# COVER SHEET

Mark-up Legend	
Building Review	
Engineering Review	
Fire Review	
Planning Review	
Public Works Review	
Traffic Review	
APPROVED	
BY	CITY OF PUYALLUP DEVELOPMENT ENGINEERING
DATE	
NOTE: THIS APPROVAL IS VOID AFTER 180 DAYS FROM APPROVAL DATE. THE CITY WILL NOT BE RESPONSIBLE FOR ERRORS AND/OR OMISSIONS ON THESE PLANS. FIELD CONDITIONS MAY DICTATE CHANGES TO THESE PLANS AS DETERMINED BY THE DEVELOPMENT ENGINEERING MANAGER.

FOR  
**ARCO ampm PUYALLUP**  
SEC. 33, TWN. 20 N, RGE. 4 E, W.M.  
CITY OF PUYALLUP, PIERCE COUNTY

3 SDMH #3 - TYPE 2 - 54" FLOW SPLITTER  
C5.4 SCALE: NTS

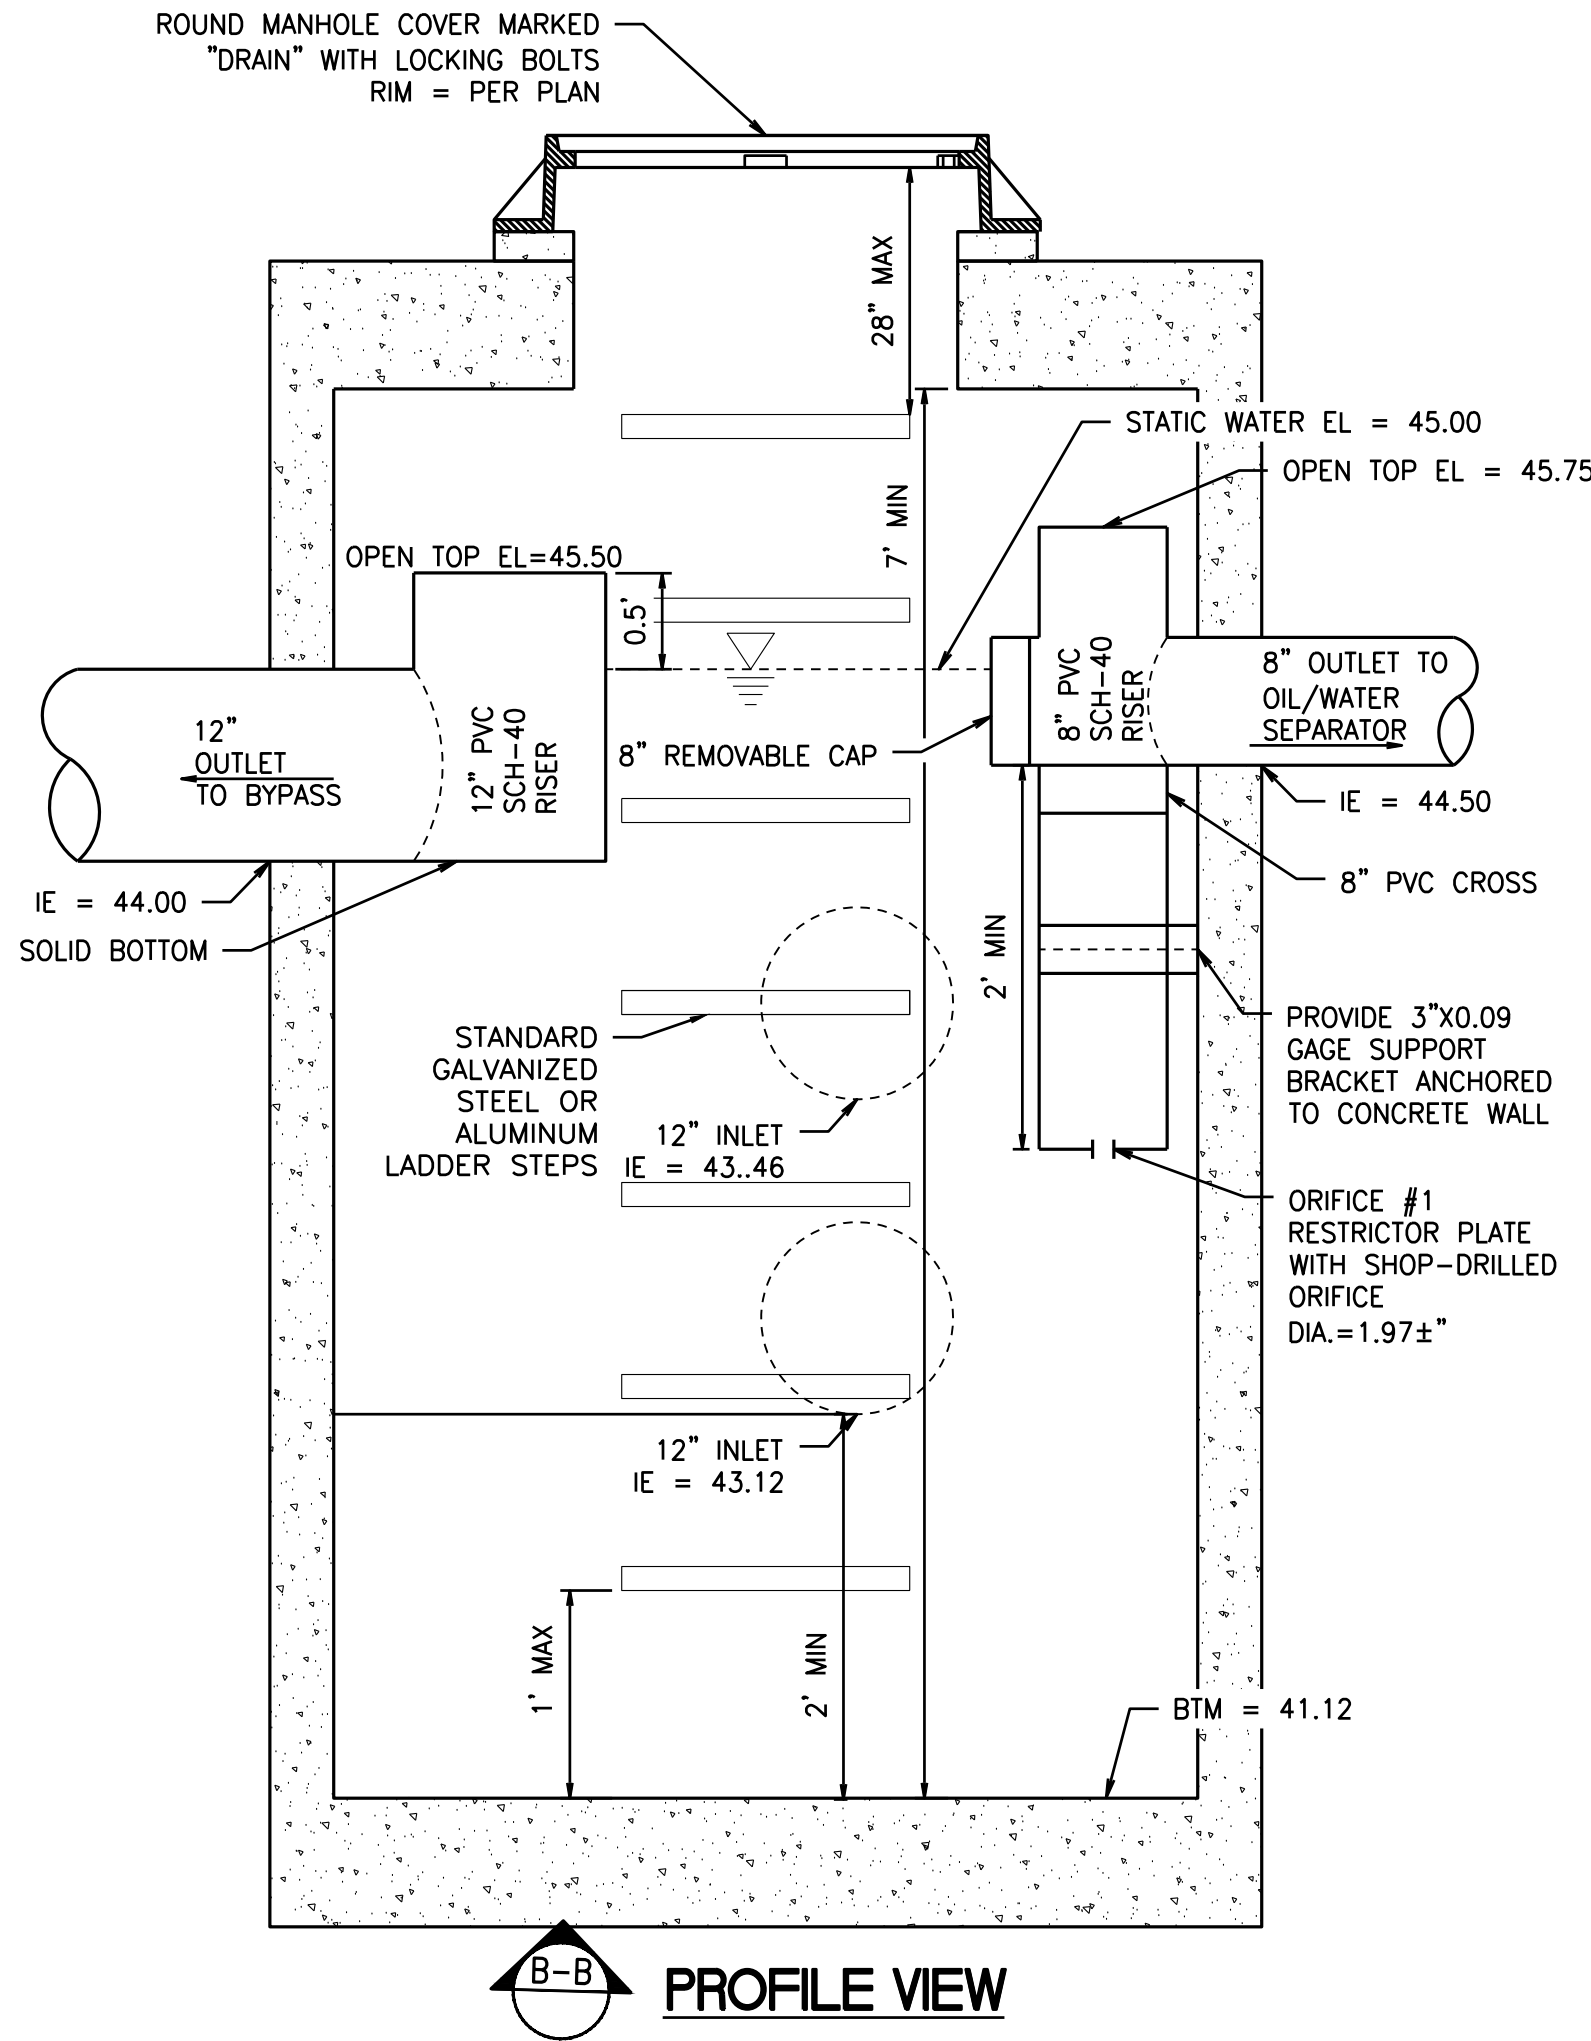
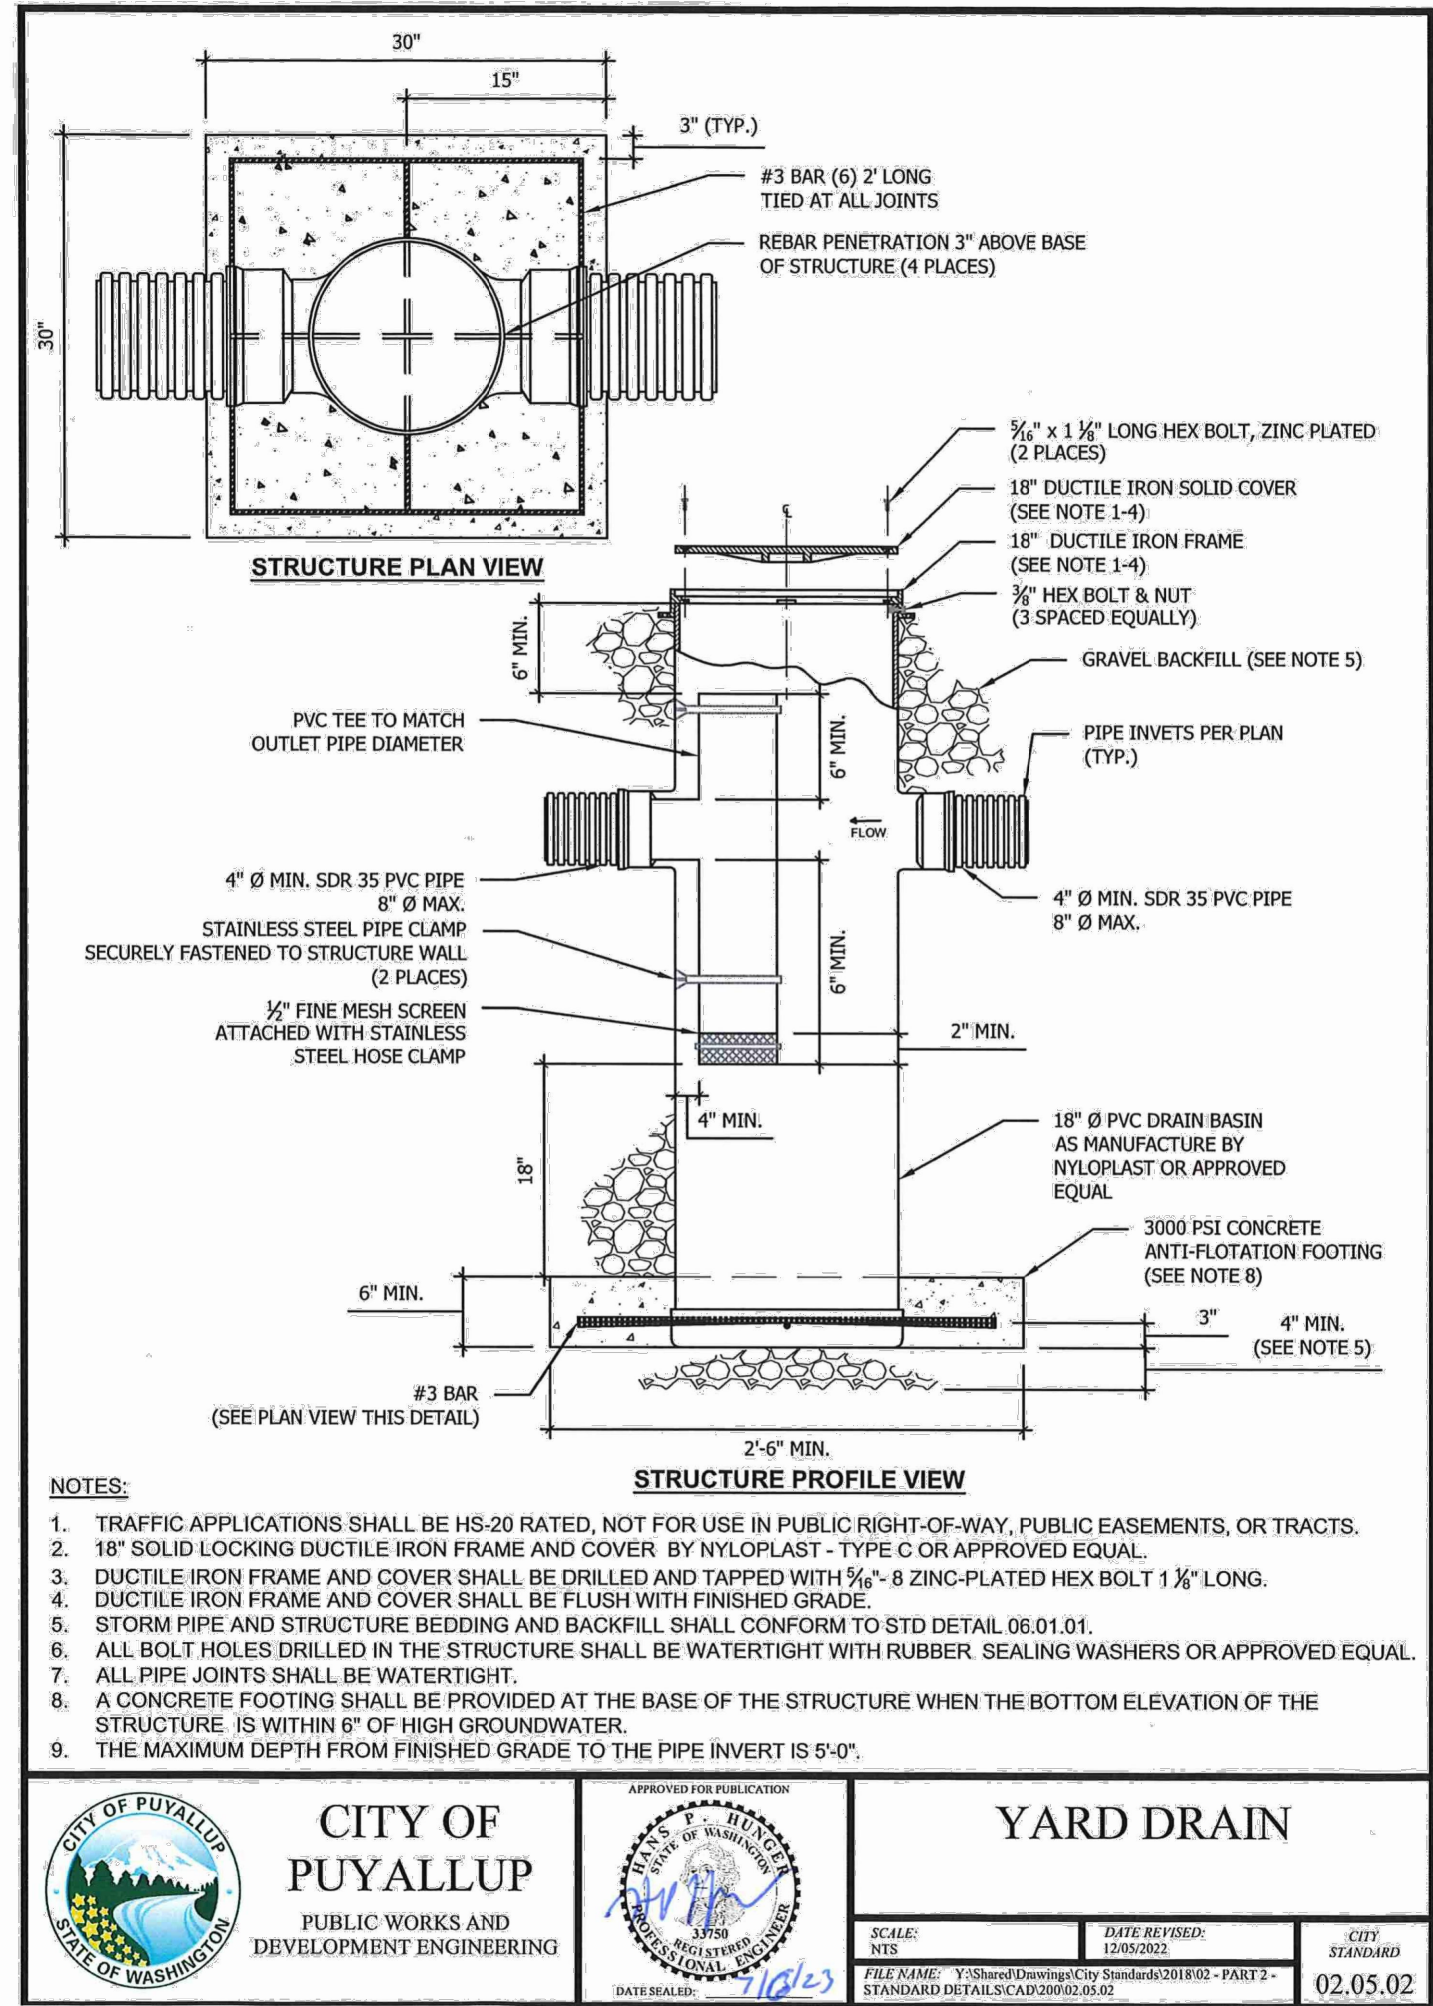
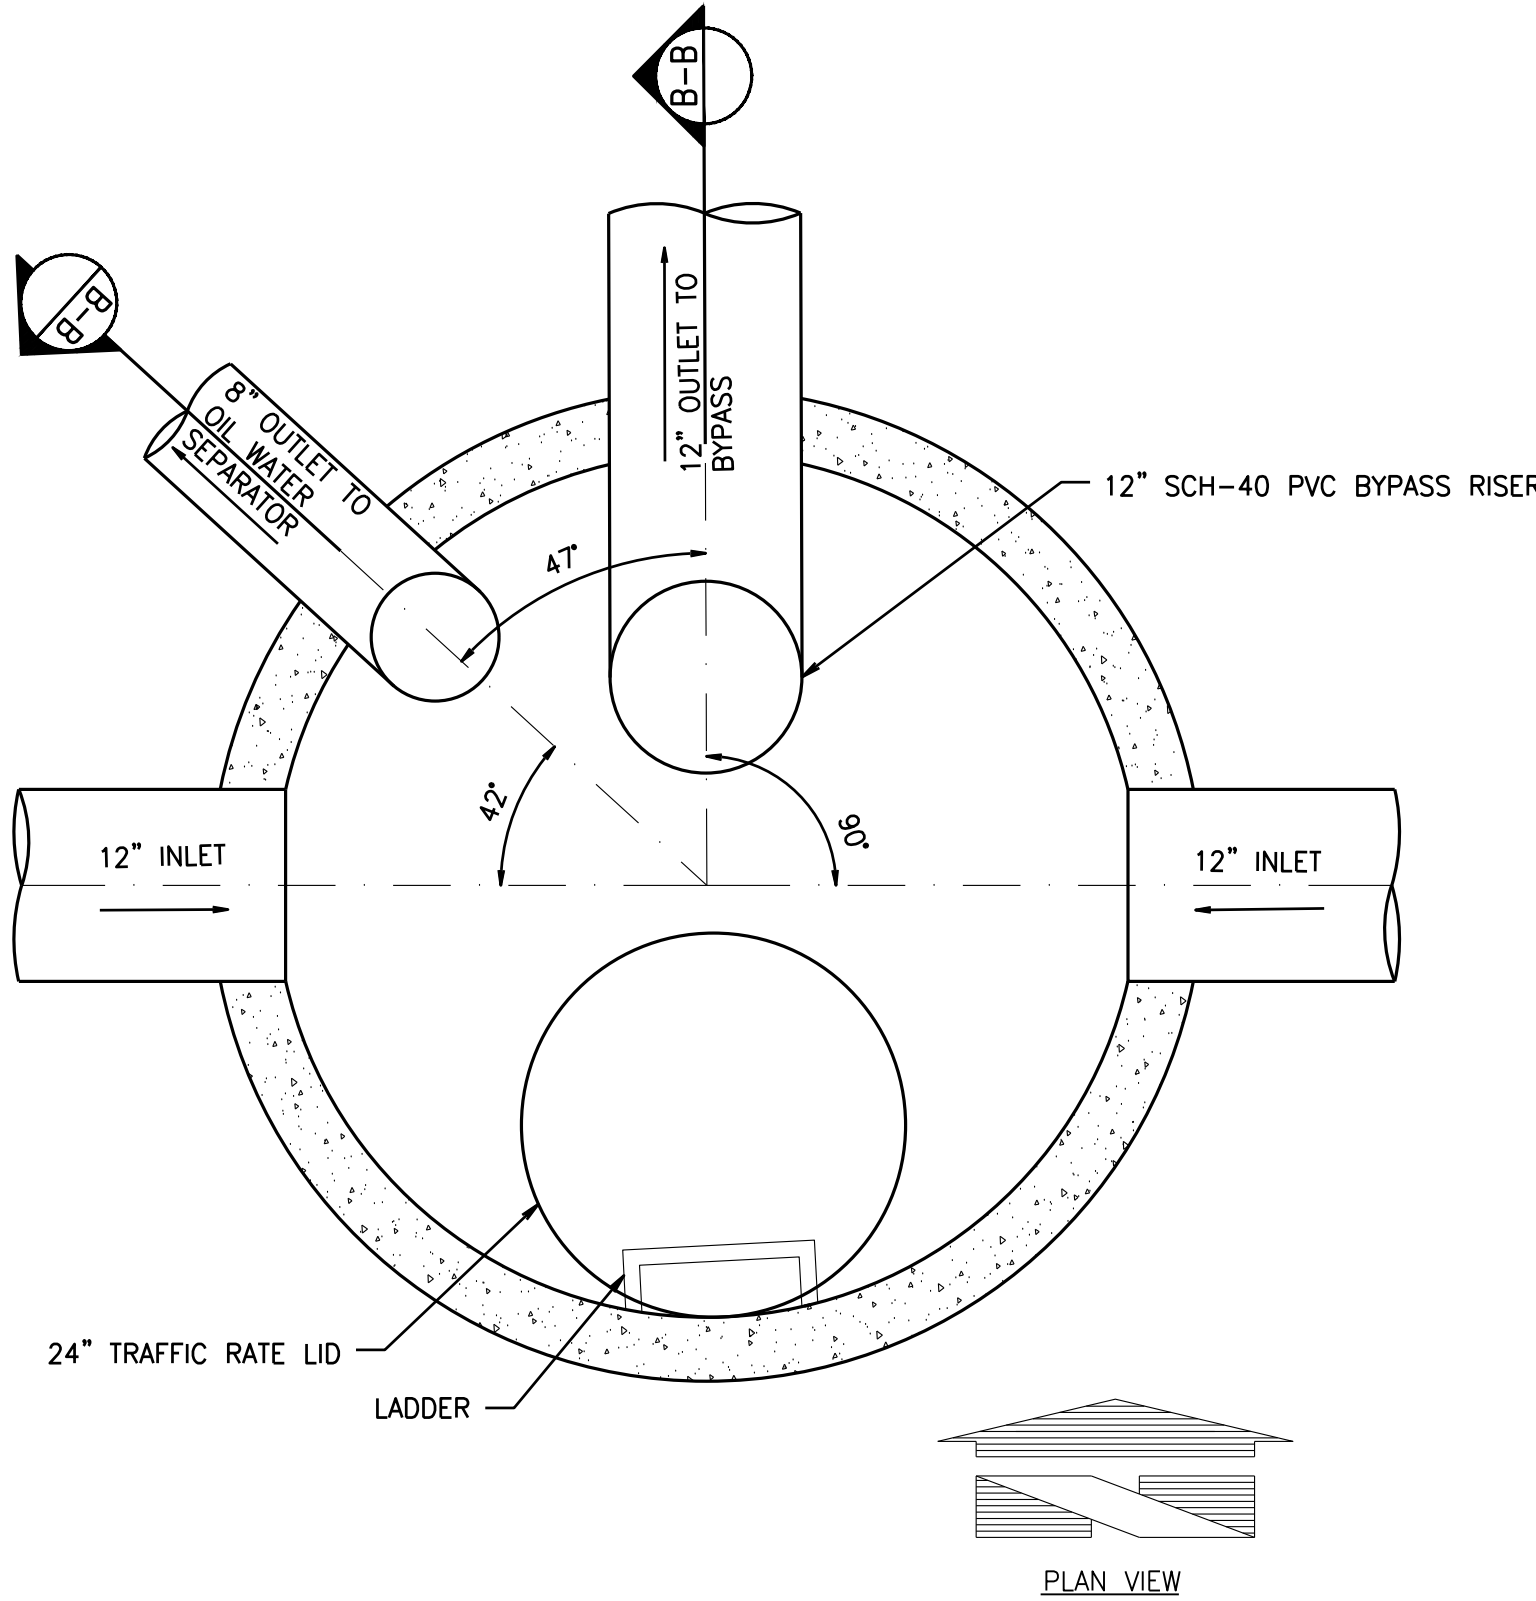
Provide a detail from the proposed beehive grate. [civils, sheet C5.4]
